STAFF REPORT: MAY 10, 2024 MEETING
APPLICATION NUMBER: HDC2024-00170
ADDRESS: 4428 SECOND AVENUE

SCOPE: REPLACE WINDOWS, INSTALL FIBER CEMENT SIDING AT REAR

SOUTH ELEVATION EXISTING CONDITIONS

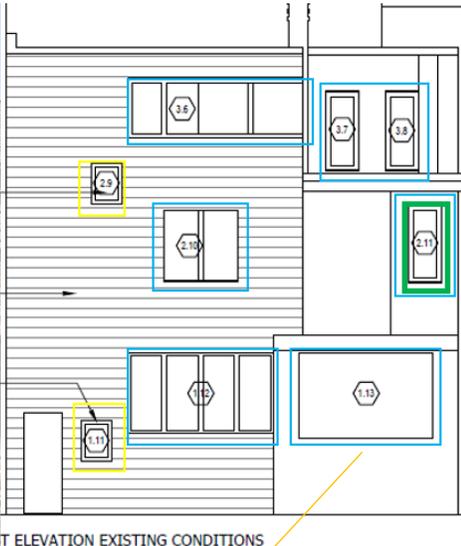
Applicant will retain the wood basement windows, as well as the single windows in the rear enclosure.

Applicant proposes to replace remaining windows on side wall.

Staff determines the wood windows on the first and second floor are character-defining features. Based on applicant photos, the windows are intact and most appear to have solid, repairable frames. Notable exception is the middle window of opening 1.7 – staff recommends a new wood window be built for this opening.

Staff confirmed the windows at the third floor are contemporary replacement units and can be replaced, per the applicant's proposal.

REAR ELEVATION EXISTING CONDITIONS

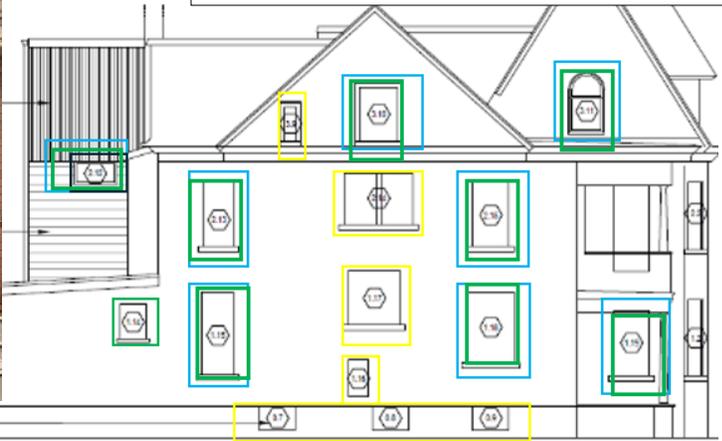
Applicant will retain the single wood windows at the three-story extension.

Applicant proposes to replace remaining windows on both rear walls.

The window units within the grouped window openings at the rear extension are not historic age, some are vinyl replacement units and opening 1.13 doesn't have any windows. Staff agrees replacement units can be installed at these locations.

The remaining three wood windows on the masonry wall of the house are historic age. Window 2.11 is intact and repairable. Window 3.7 has additional deterioration due to exposure from an a/c unit. Due to the rear and recessed location of these openings, and their location in the roof (meaning the windows aren't deeply recessed within their openings) and minimal dimensional change of the proposed replacement units, staff feels that the proposed replacement units in this location, meets the criteria of the National Park Service document [Replacement Windows that meet the Standards](#).
